RHINO-RACK®

TEMPORARY CHANGE TO THE FITTING INSTRUCTIONS FOR
SUNSEEKER 2.0M AWNING (PART NO. 32132)
SUNSEEKER 2.5M AWNING (PART NO. 32133)

Supply period

26 March 2021 - 15 July 2021

DO NOT USE	GOOD TO USE
<p data-bbox="347 1473 671 1514">Square head T-Bolt</p> 	<p data-bbox="884 1473 1294 1514">Rectangular head T-Bolt</p>

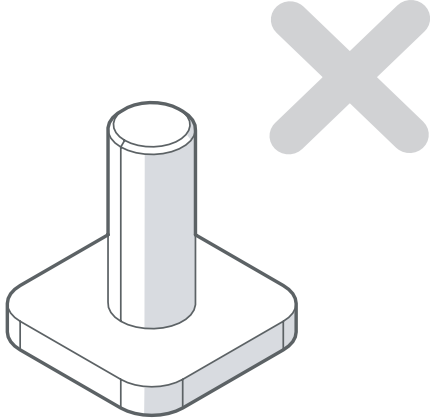
The M8 T-Bolts (Item 26) in the fit kit have been reworked.

The **rectangular head T-Bolts (included)** are to be used

for installation of the awning.

if square head T-bolt's has been supplied, discontinue installation and

Refer to fitting "**Rhino-Rack SUNSEEKER Awning Black**" fitting instruction steps

1A and **1B** to assemble correct rectangular T-Bolts
